**PARK CITY BOARD OF ADJUSTMENT MEETING
SUMMIT COUNTY, UTAH
January 9, 2024**

Board of Adjustment Staff Report

Subject: 948 Woodside Avenue
Application: PL-23-05967
Author: Spencer Cawley, Planner II
Date: January 9, 2024
Type of Item: Variance

INDENTATION

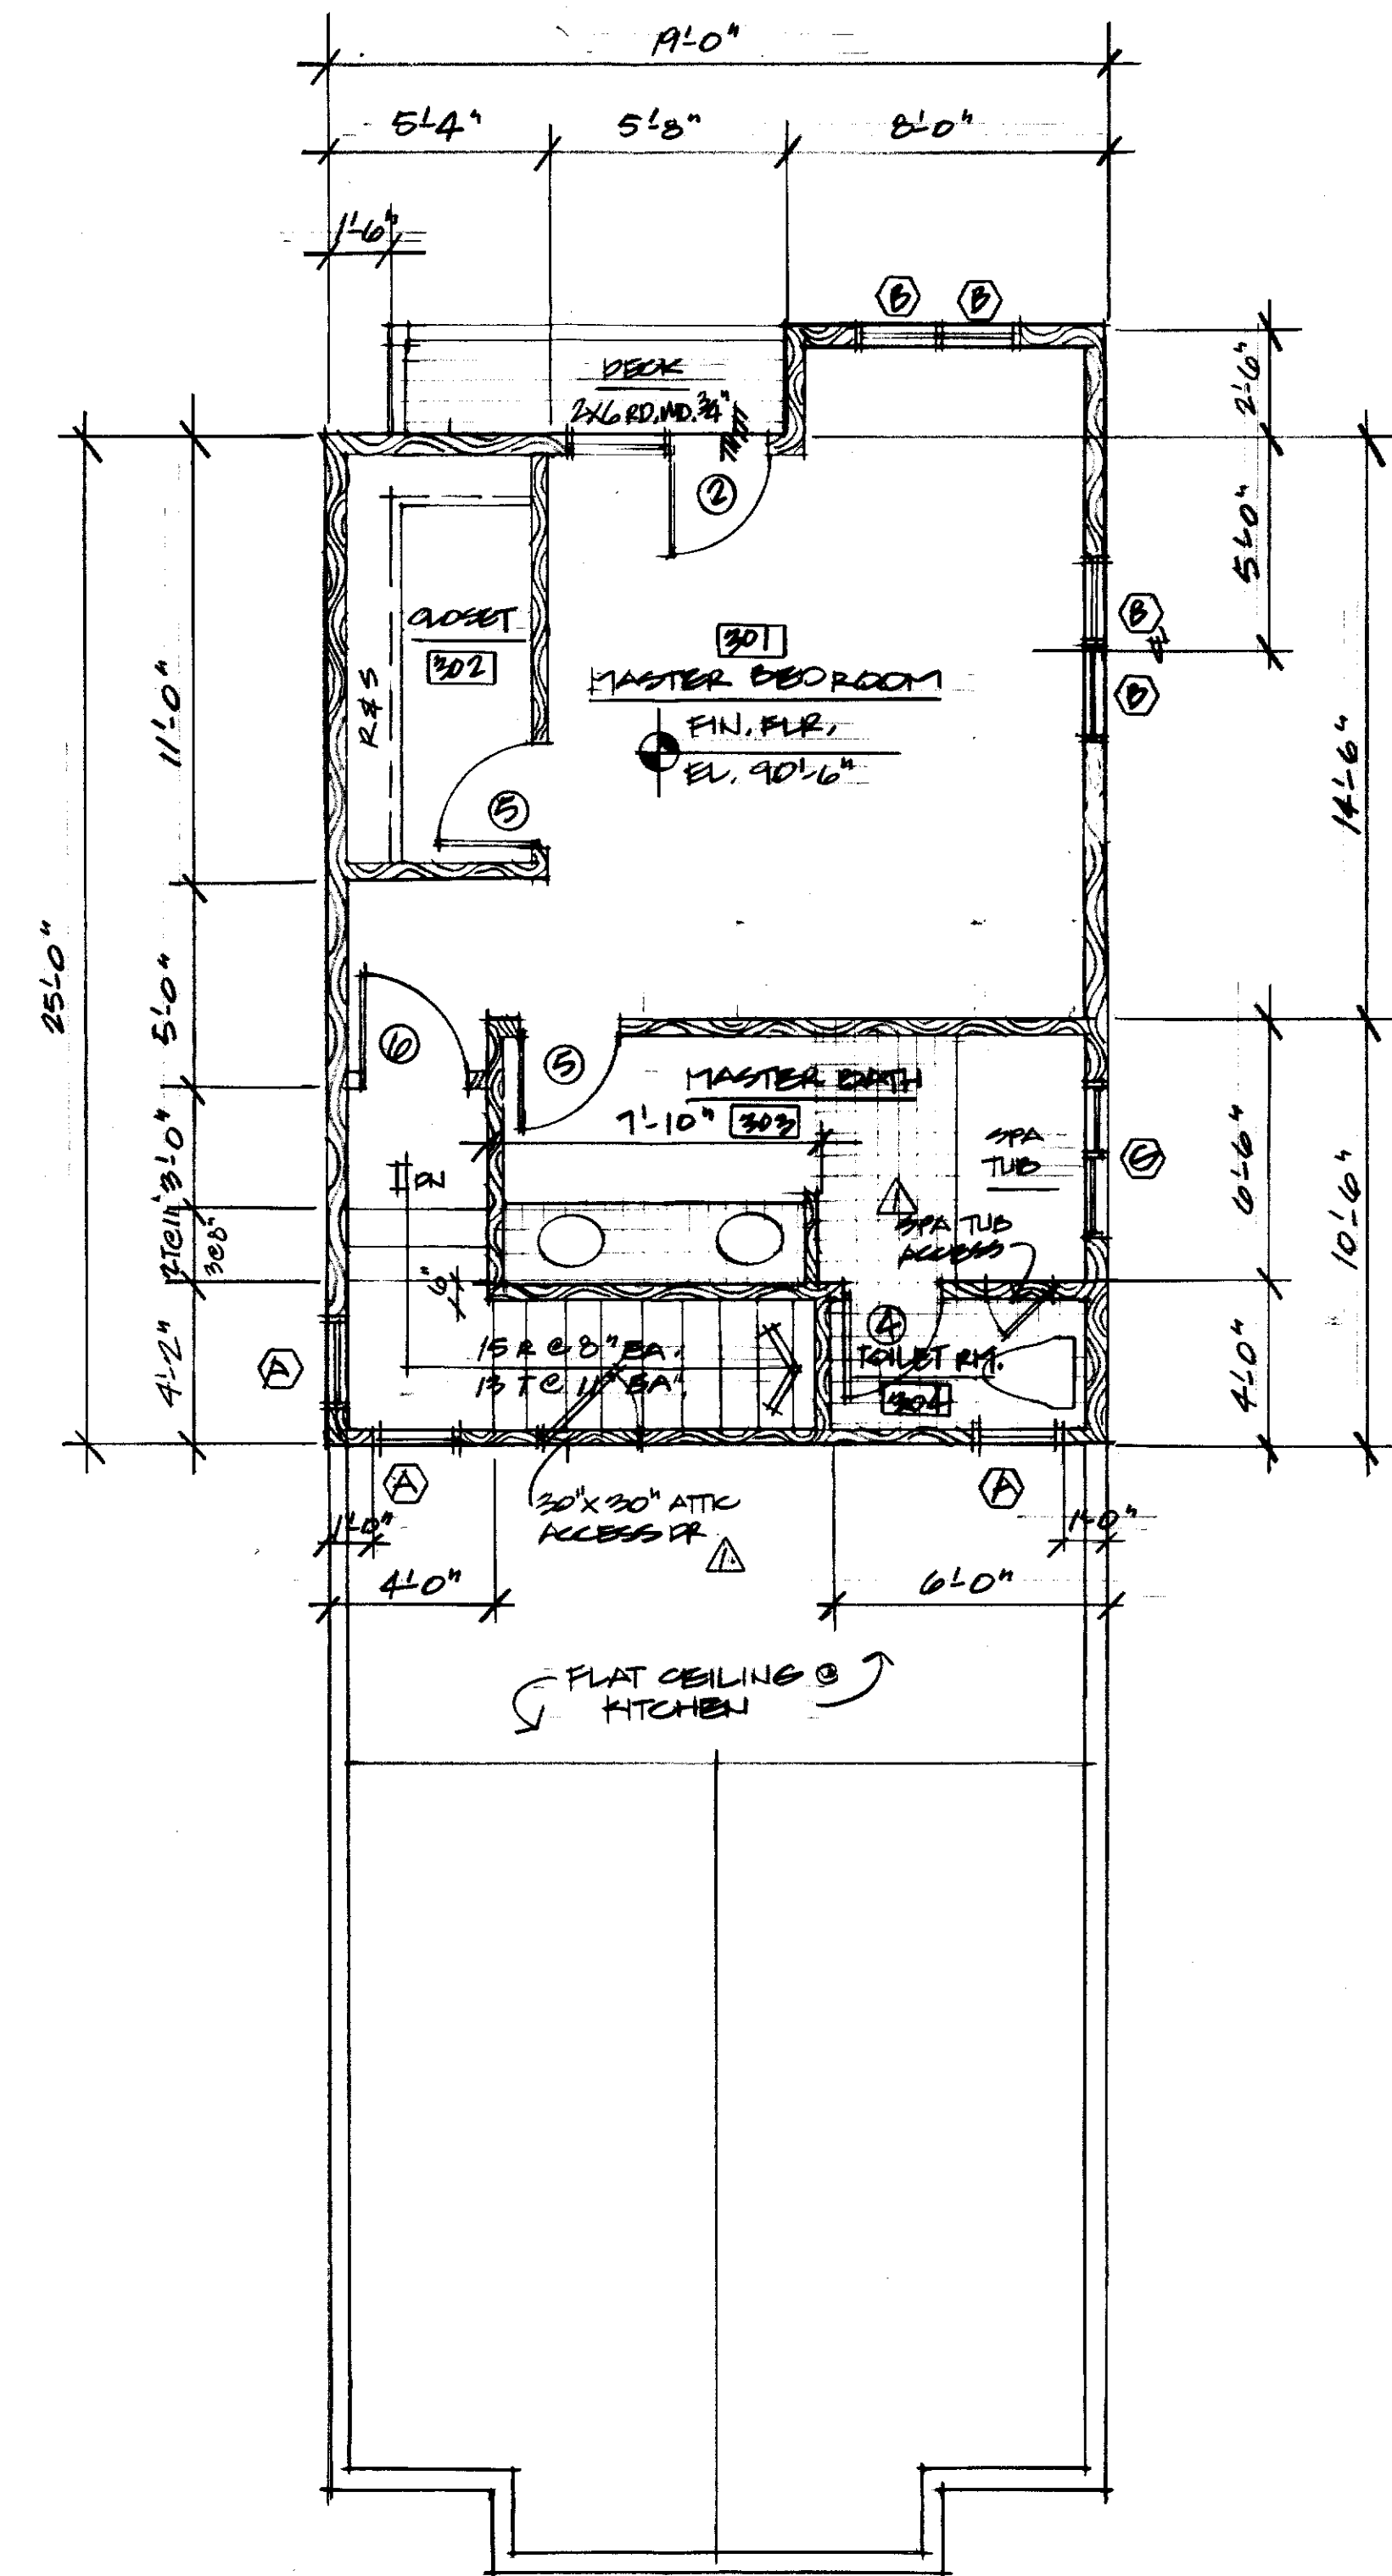
2. There are special circumstances attached to the Property that do not generally apply to other Properties in the same zone.	Applicant's Response: <i>The Applicant's request is to create a bathroom where the indentation exists in the grade-level foundation [which is] unique to 948 and 946 Woodside (mirrored homes built at the same time) and differs from other homes in the neighborhood. One goal is no longer to have twin homes but differentiate the two homes. The grade-level foundation is unique to both 948 and 946 Woodside</i>

<i>and differs from other lots in the area due to the individual lot's narrow dimensions. Currently the building footprint for 948 Woodside is a rectangle that includes a small "indentation" below grade on the front left side of the house (5' x 10') The original reason of the indentation is unknown; however, it is speculated that it may have been intended for the addition of an outdoor A/C/ condenser. The requested modification will not extend the footprint however it will "fill-in" the "indentation" and make the footprint a perfect rectangle. By enclosing the below grade indentation [the Applicant] will be adding ~50 square feet to the footprint square footage. The enclosed space will be used to provide a small basement bathroom to service one of the three basement rooms.</i> <u>Recommended Finding:</u> 948 Woodside Avenue has a slope of less than 14%. LMC <u>§ 15-15-1</u> defines Steep Slope as a slope greater than 15%. 948 Woodside Avenue is, therefore, not impacted by Steep Slope considerations. The Property is not near a wetland or stream. The Structure is not designated a Historic Structure on the Park City Historic Sites Inventory. As a result, no special circumstances are attached to the Property that do not generally apply to other Properties in the same zone.

4. The Variance will not substantially affect the General Plan and will not be contrary to the public	<u>Applicant's Response:</u> <i>This small indentation in the footprint is below grade and not seen from the road or other properties. The second and third floors of the home have already</i>

interest.	<i>been built above this “indentation”, so it appears from the street view that the space is already being utilize[ed] where the indentation exists. Again, since the home’s levels above the “indentation” are over said “indentation” the casual observer assumes it does not exist.</i>  <u>Recommended Finding:</u> Historic Character is one of the core community values outlined in the General Plan. Goal 15 of the General Plan is to preserve the integrity, mass, scale, compatibility, and historic fabric of the nationally and locally designated historic resources and districts for future generations. Objective 15B is to maintain the character, context, and scale of local historic districts with compatible infill development and additions. The HR – 1 Zoning District maximum Building Footprint is established in part to support compatible infill in the City’s Historic Districts. Allowing a Building Footprint that already exceeds what is allowed to increase the non-conformity is contrary to Goal 15 of the General Plan and does not preserve the integrity, scale, compatibility, and historic fabric for future generations.

Objective 15B is to maintain the character, context, and scale of local historic districts with compatible infill development and additions. The HR – 1 Zoning District maximum Building Footprint is established in part to support compatible infill in the City's Historic Districts. Allowing a Building Footprint that already exceeds what is allowed to increase the non-conformity is contrary to Goal 15 of the General Plan and does not preserve the integrity, scale, compatibility, and historic fabric for future
